City of Richmond
Urban Development Division

**Report to
Development Permit Panel**

To: Development Permit Panel
From: Joe Erceg
Manager, Development Applications
Date: April 15, 2003
File: DP 03-227595
(Part 1 – Building only)
Re: **Application by Great Canadian Casinos Inc. for a Development Permit at
8811/8831 River Road**

MAIN FLOOR PLAN
SCALE: 1/8" = 1'-0"

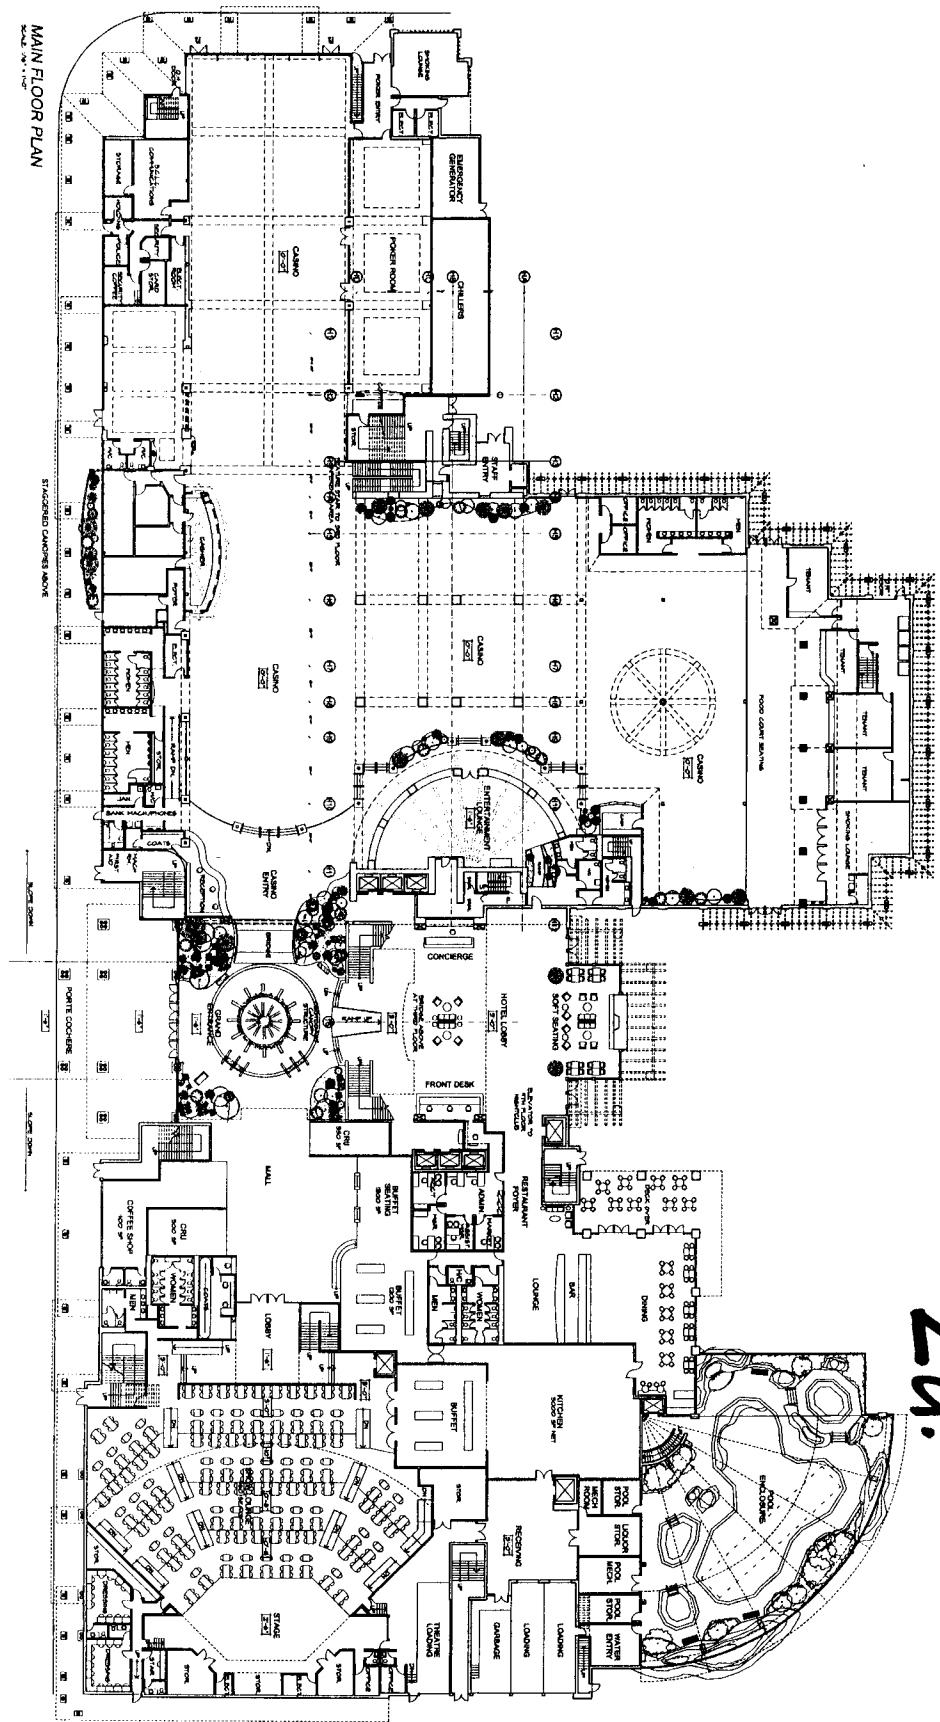
- a) Along the south elevation, the commercial retail units (CRU's) could be flipped with the washrooms on both sides of the main lobby to create both commercial shop entries and display windows that flank the lobby entrance to the hotel. ***The applicant has added windows to a coffee shop next to the main entrance that extends as far as possible to the east.***

- The suggestion to flip the washrooms on the south perimeter wall with the internal commercial retail unit (CRU) has been adopted. It is now anticipated that the CRU will likely be a coffee shop or breakfast oriented restaurant with direct access to the exterior. The applicant was adamant that glazing could not be added to the casino rooms for security reasons and the architect did not feel that creating additional transparency elsewhere around the perimeter of the building was appropriate.

1. Increase the transparency of the envelope for every use around the perimeter of the building. *The applicant has agreed to increase the transparency of the building with the introduction of a coffee shop to the east of the main lobby entrance on the south side of the building facing River Road, however there are other locations where the transparency of the building could be increased. The applicant has vigorously resisted providing glazing along any exterior wall of a casino room and City of Richmond staff have accepted this position, however the applicant has agreed to provide large display cases or windows along the south and east elevations of the building. In addition, the applicant has now provided additional glazing at the north-west corner of the building at the staff entry lobby in combination with a smoking area. City of Richmond staff support the design direction of improving the facade material around the podium level of the building and other previously agreed techniques to increase the envelope transparency including additional glazing and improved animation and interest in the form of display cases or windows, however at the time of writing this report, the architectural drawings do not currently reflect all the proposed changes.*

SOUTH ELEVATION

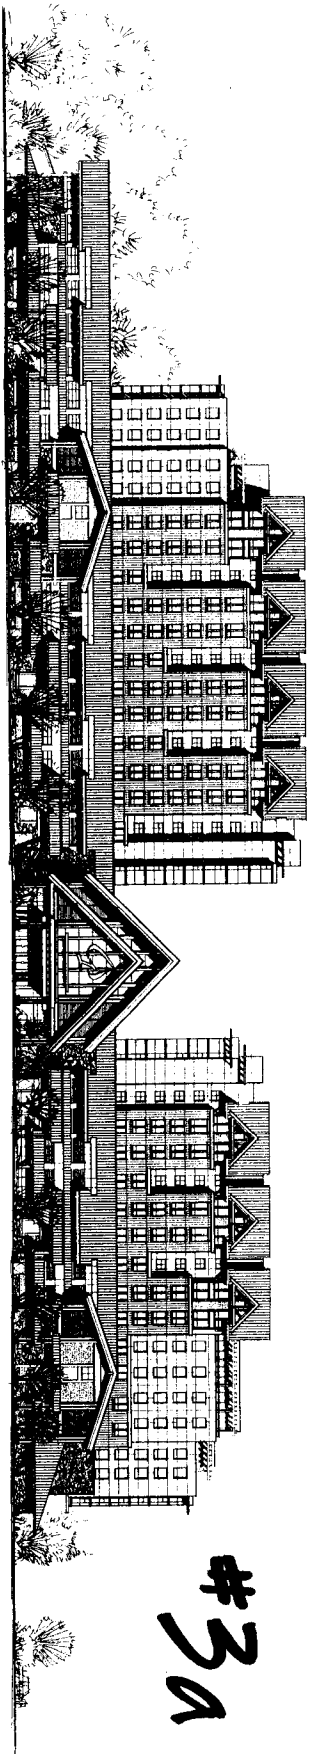
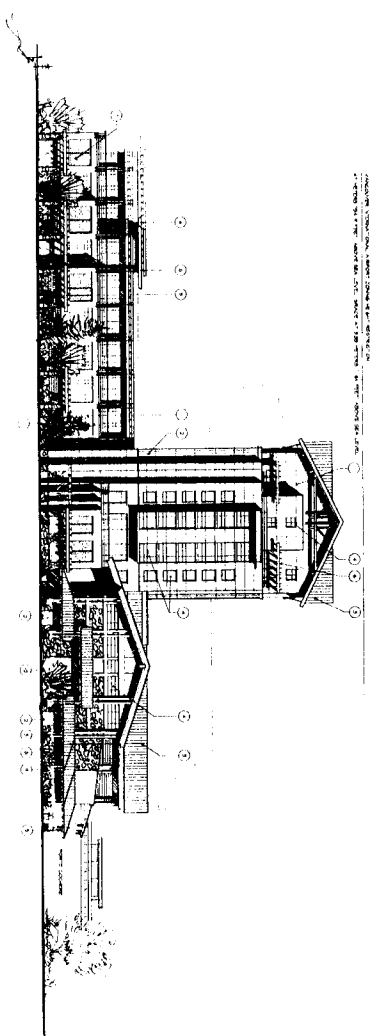
8. There are too many large blank walls around the perimeter of this building. The Advisory Design Panel made the comment that this building is relatively isolated in the landscape and is visible from many vantage points and from a variety of angles. In this regard, the east and west elevations of the building are noticeably devoid of architectural interest and require significant design development. ***The applicant believes this issue has been dealt with in a satisfactory manner.***

- The wall on the south side of the project remained 'flat' and two-dimensional in appearance. The re-design of the upper tower elements was supported; in particular the use of natural materials and the sculptural qualities of the revised top 2 floors. It was requested that the architect and applicant consider an enriched entertainment/activity program to complement the broader function of this development. Support for the 'A' frame roofs was expressed but it was felt that further design development was necessary and suggested 'tipping' or 'canting out' some structural elements at the top of the tower elements to create an 'eye-brow' appearance. Suggestions were given for further segmentation of the roof form and further design development of the roofscape.

NORTH ELEVATION

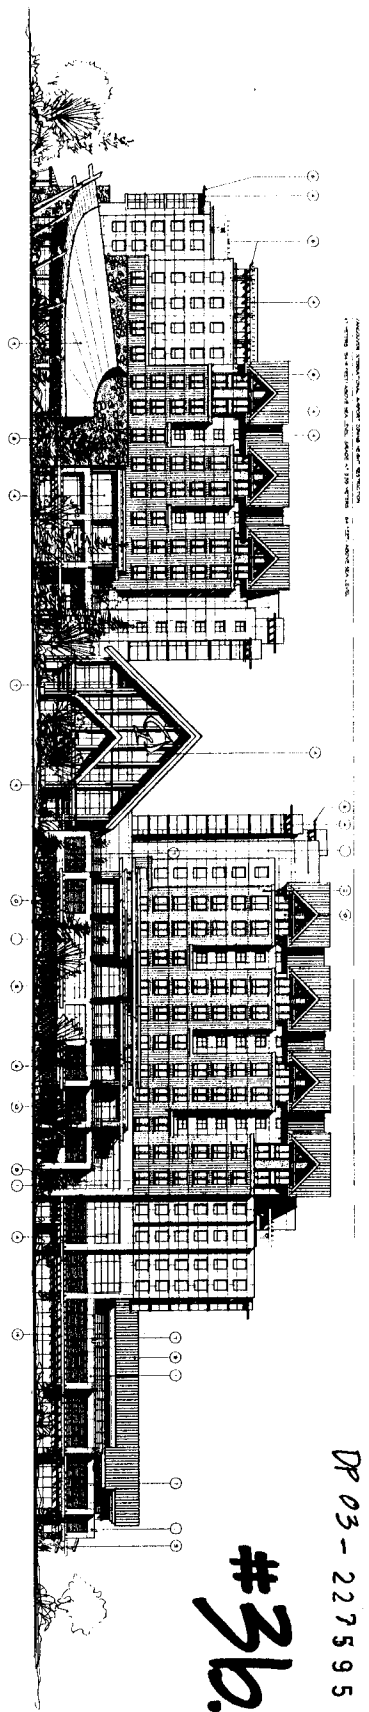
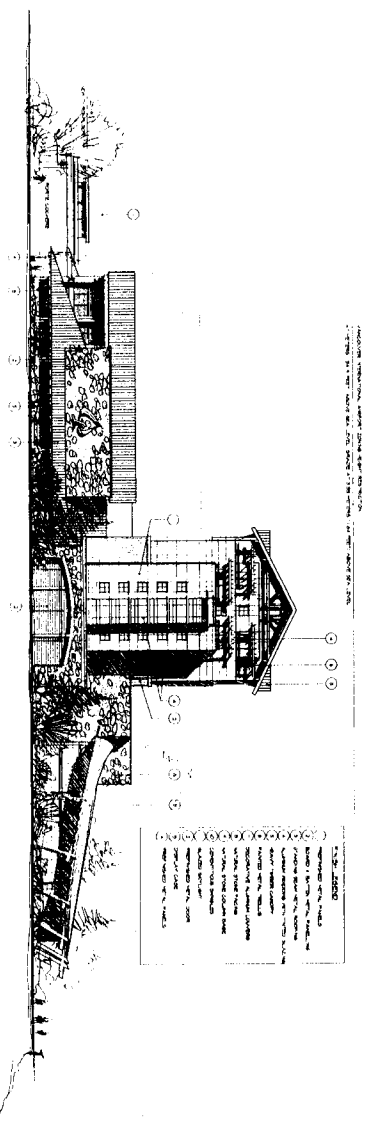
- b) Along the north perimeter wall of the north casino room, the food concessions could front or have order windows directly from the waterfront walkway. ***This will not be possible due to the constraints of the BC Lotteries regulations and the client's desired program requirements. These areas will receive abundant landscape treatment to create the visual imagery of a transparent crystalline structure (Casino head office) supported by a well-finished podium that appears to rise from the naturalistic landscape that included rock forms, planted material and water features in several areas. This is the proposed treatment around the three (3) sides of the actual Casino part of the building.***

4. There is an uncomfortable relationship between the building and the waterfront walkway at the north-west corner of the building. The lack of architectural design development and building articulation are general concerns with regard to the building facade in this location. The applicant is requested to provide a more appropriate building facade that better relates to a 'pedestrian scale' and that incorporates visual interest along the waterfront walkway. ***The applicant has revised and improved the building facade at the north-west corner, including the elimination of stucco, the addition of envelope articulation, the incorporation of a heavy timber and stone trellis, plus natural/artificial rock work bermed up against or adjacent to the building.***

4. Address the uncomfortable relationship between the north-west corner of the building and the waterfront walkway. *The applicant has explored the possibility of a boardwalk out over the marsh but this approach was not supported by the Department of Fisheries and Oceans Canada. Therefore, the applicant has decided to make various facade modifications near the north-west corner of building. These include the elimination of stucco on the podium of the building, the incorporation of natural cladding materials, the introduction of building facade articulations, enriched detailing of the building facades, further design development to better integrate the mechanical vents into the facade treatment, the addition of a continuous, heavy timber and stone trellis system, artificial and/or natural stone landscape screening bermed up against or adjacent to the building, the introduction of some glazing at the north-west corner of the building and the limited use of metal panelling. City of Richmond staff supports the general design direction of the facade treatment at the north-west corner of the building.*
